City of Ramsey
Agenda
Environmental Policy Board (EPB)
Monday, June 17, 2019
6:30 pm
Council Chambers, 7550 Sunwood Drive NW

Consider Landscape Plan for Suite Living; Case of Hampton Companies

DATE	JUNE 11, 2019	PROJECT ADDRESS	TBD
PROJECT. TITLE	SUITE LIVING		
ESCROW #	117010		
DEPARTMENT:	Planning Division (Landscape Plan & Environmental Resources)		
TECHNICAL REVIEWER:	Name: Chris Anderson Phone: 763-433-9817 Email: canderson@cityoframsey.com

DATE	JUNE 12, 2019	PROJECT ADDRESS	TBD
PROJECT. TITLE	RAMSEY STORAGE CENTER		
ESCROW #	116999		
DEPARTMENT:	Planning Division (Landscape Plan & Environmental Resources)		
TECHNICAL REVIEWER:	Name: Chris Anderson Phone: 763-433-9817 Email: canderson@cityoframsey.com

1 SITE LANDSCAPE PLAN
L1

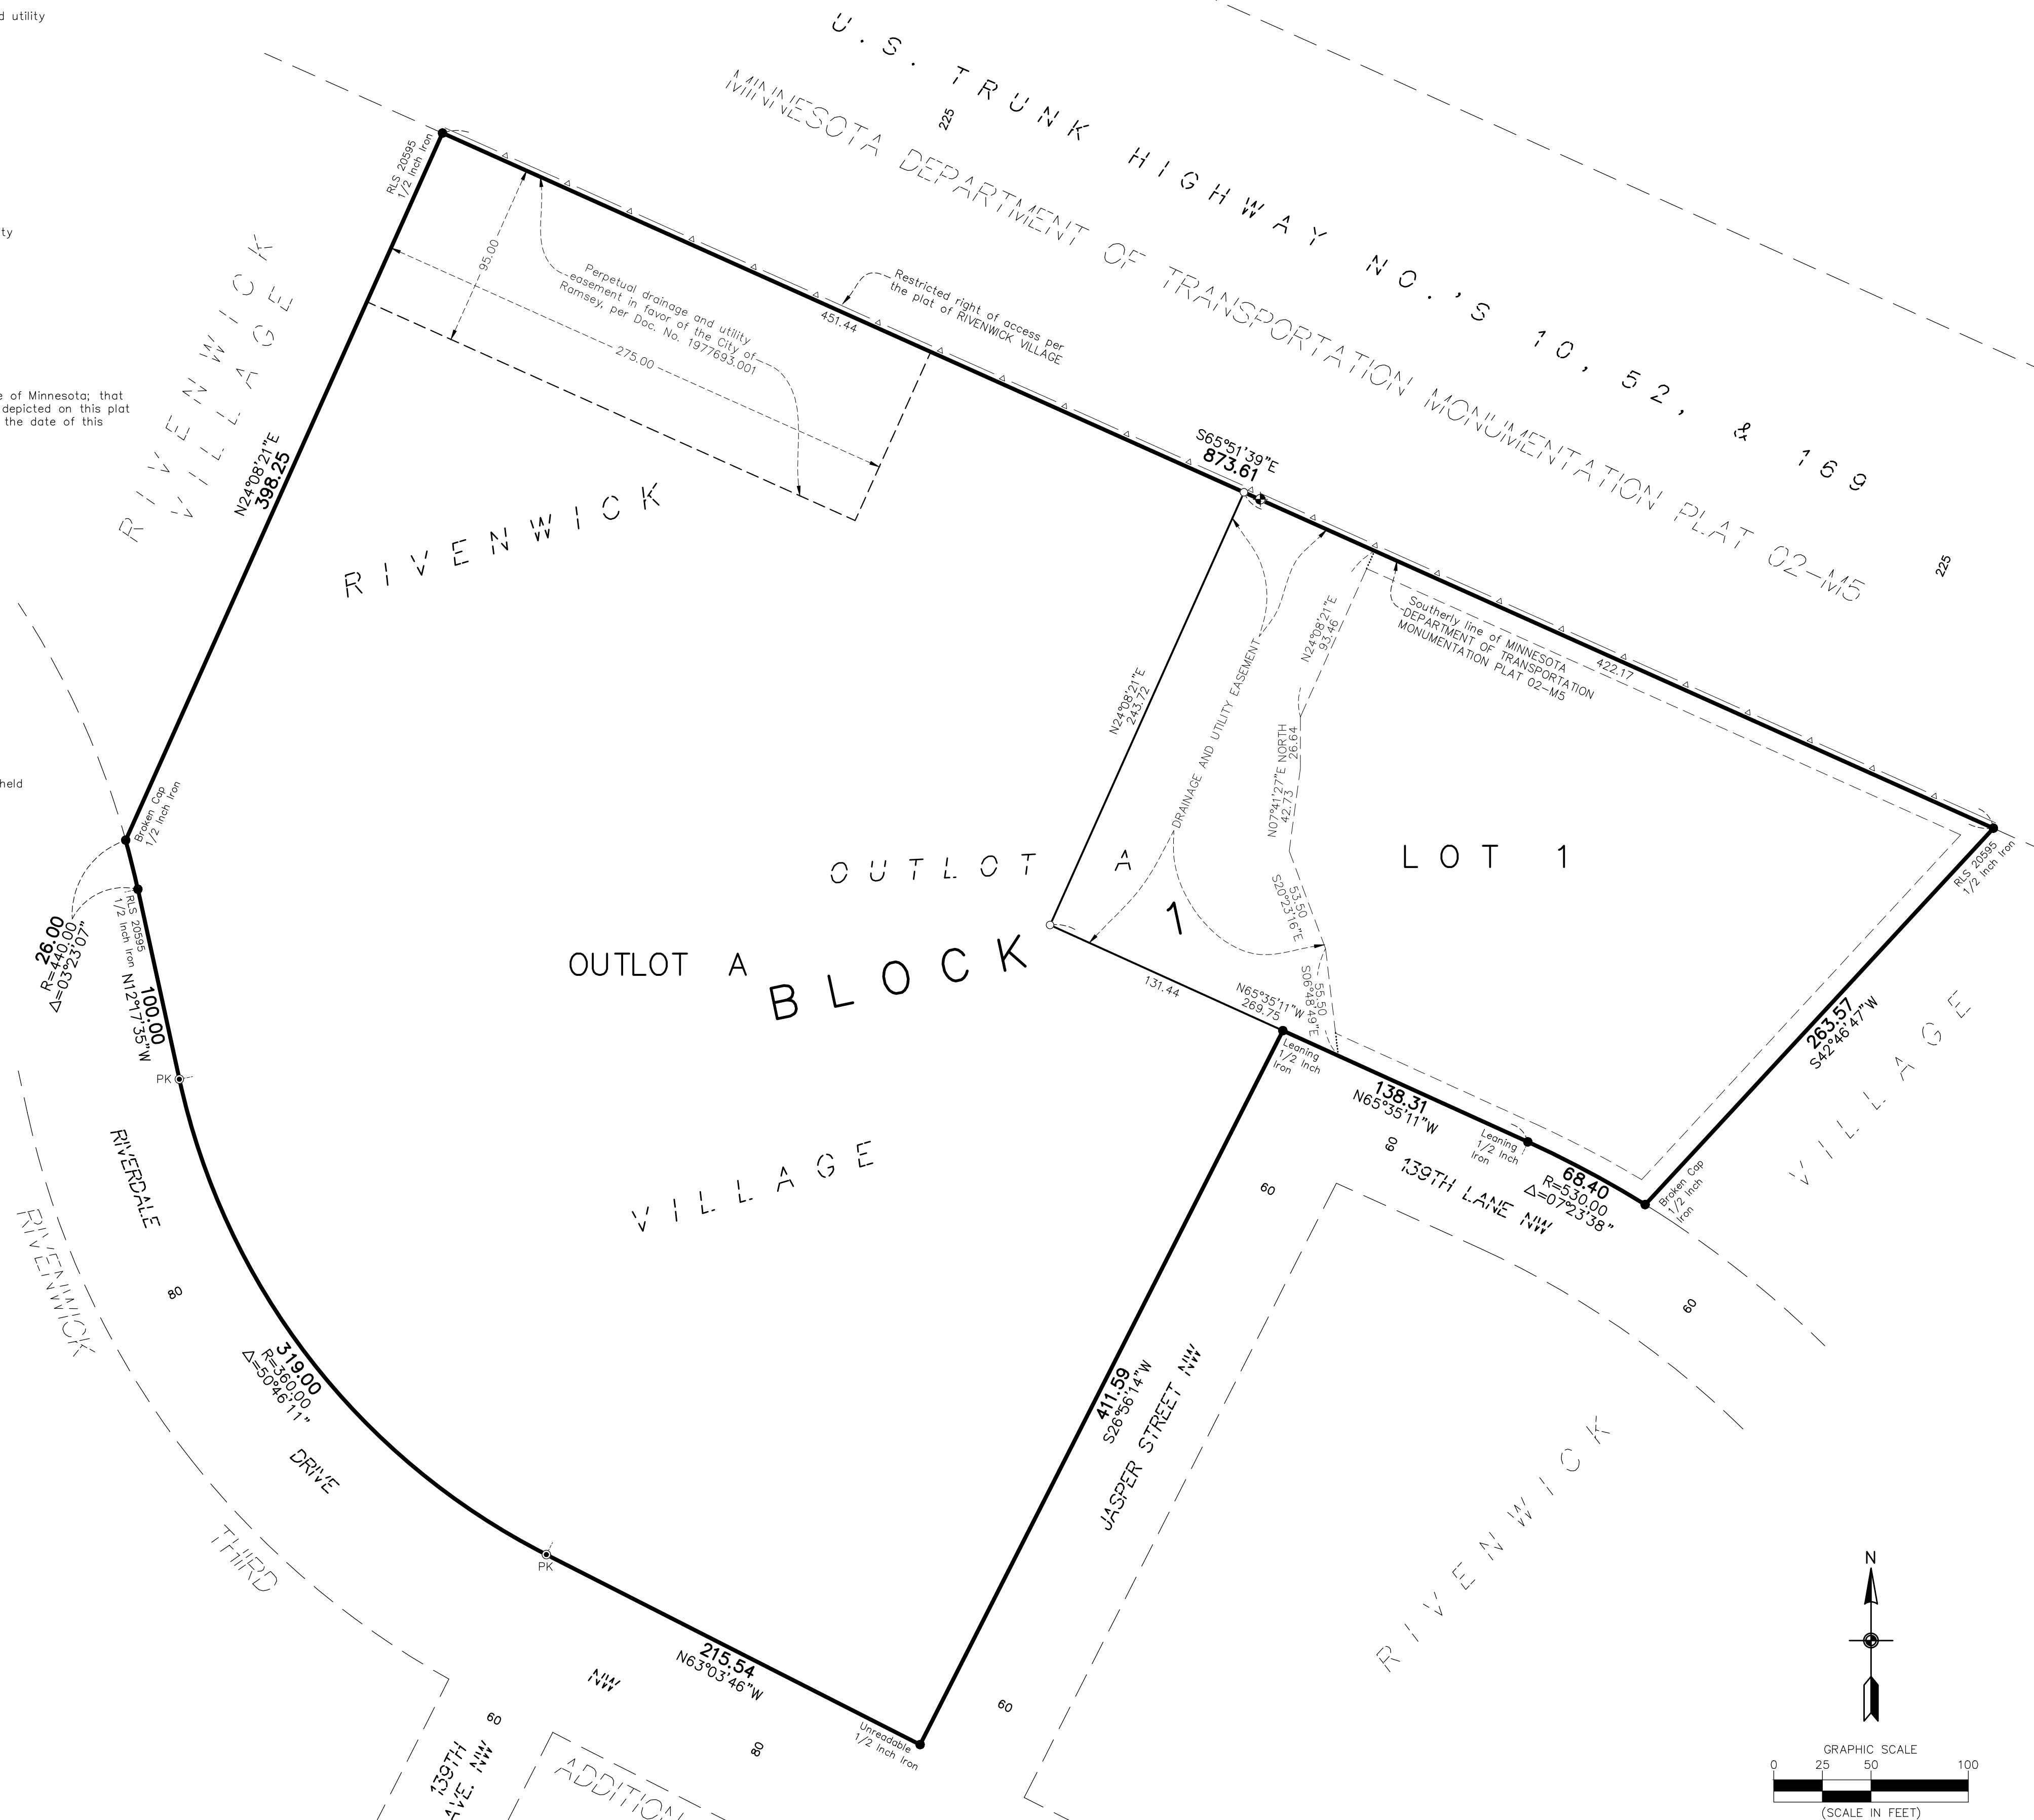
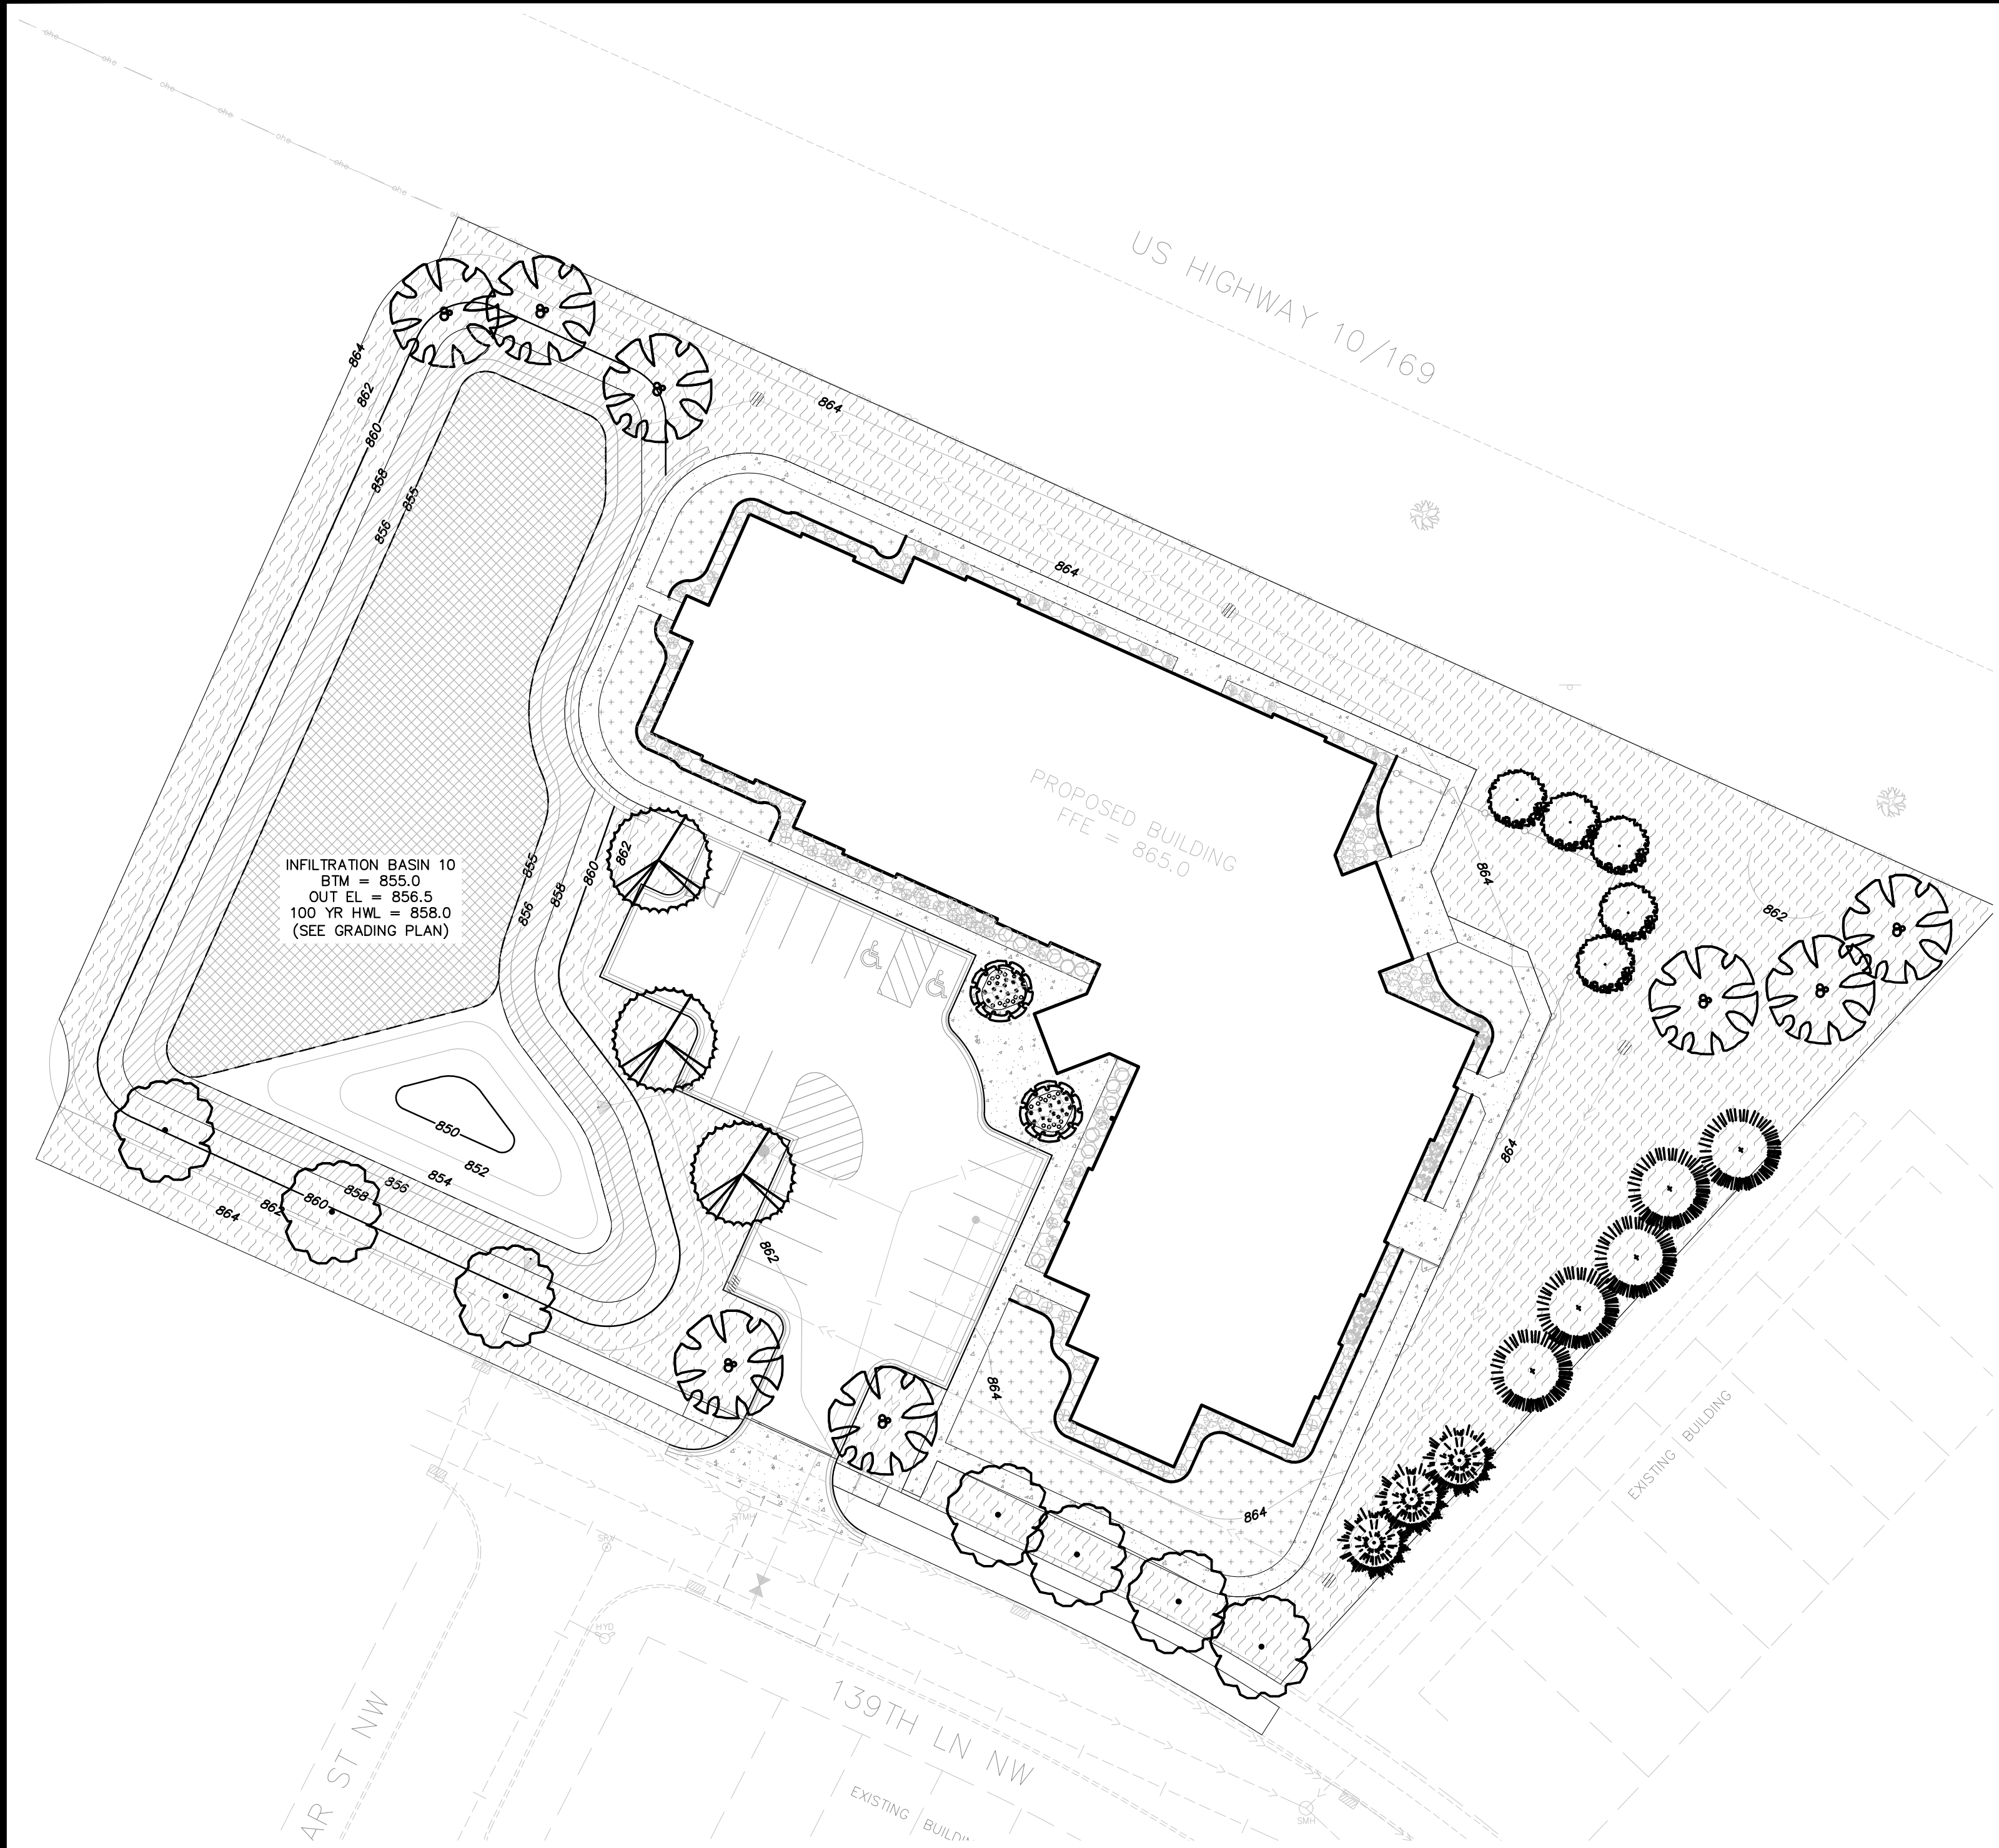
Sheet L1

- Canopy Cover Calculation is slightly off. Based on data from Sheet C3, the calculation should be $0.38 \times 57,404 = 21,814$ square feet of required canopy cover. Update accordingly.

- Based on Canopy Cover Calculation, additional plantings are required and should be in the form of shade trees.
- Under City of Ramsey Requested Notes, #4 can be eliminated as it does not apply to this project; also, notes #5 and #9 should be modified as load tickets are no longer required.

- Site is adjacent to an existing R-2 Residential (Medium Density) neighborhood and therefore a thirty (30) foot wide bufferyard, with an additional 10% of plantings is required. This equates to an additional 2,181 sq. ft. of plantings, which must be within the thirty (30) foot bufferyard area, and shall consist of evergreen trees.

- Within the boulevard/right-of-way area, sod is required. Revise the plan accordingly.
- Use of seed anywhere else on the project site requires approval of the City Council. Staff does not object to this, but would encourage the use of sod up to the internal walkway along 139th Lane.
